ISSUE DATE:	07/13/2023
SERVICE BULLETIN SUBJECT:	ZX5.A02 Spring Software Release and Shutdown Override Momentary Switch Retrofit
VINs or MODELS AFFECTED:	Service Specified Buses
COMPLETE BY:	Next Service Opportunity
SERVICE BULLETIN #:	SC-23-109
LABOR OPERATION CODE:	PE47Z
LABOR TIME	2.5 Hours

ZX5.A02 Spring Software Release and Shutdown Override Momentary Switch Retrofit

Shutdown Override Momentary Switch Retrofit (PN 188-6122):

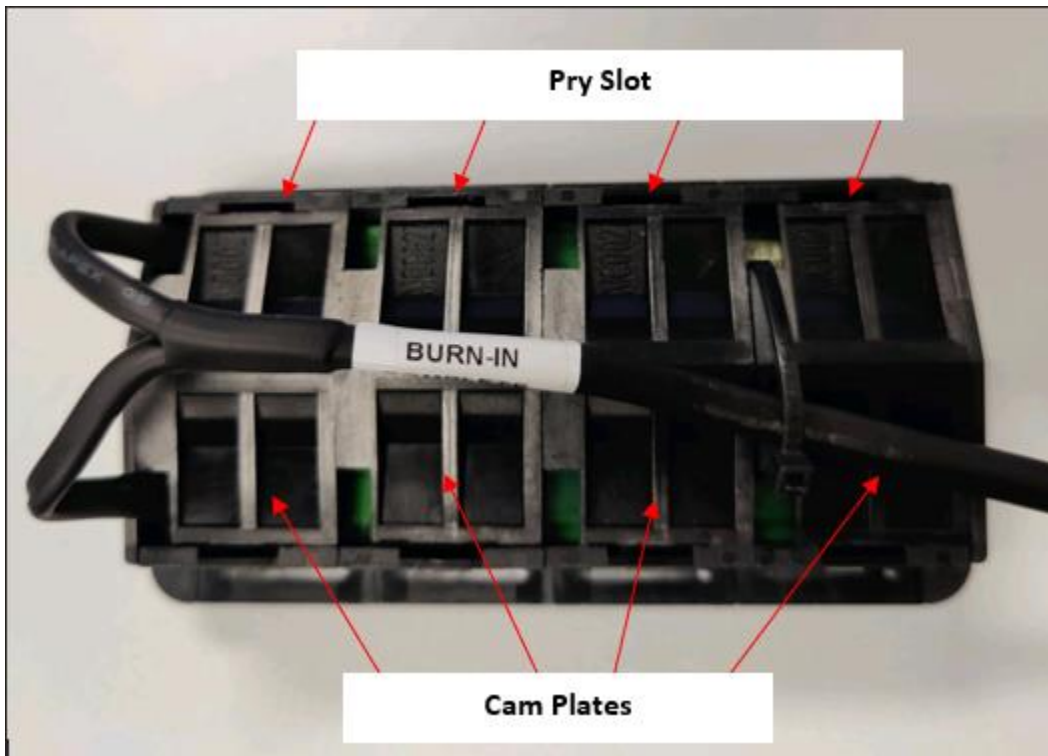
4. Remove the current CAM plate allocated to the Shutdown Override button. Use a flat head screwdriver inserted into the pry slot to pry out the cam plate. If required, remove the zip tie securing the electrical pigtail.

5. Install the Momentary cam plate PN 188-6122 (MC0030) at the Shutdown Override location by pressing it into place. Verify orientation of the cam plate such that the front of the button is raised. See picture below.
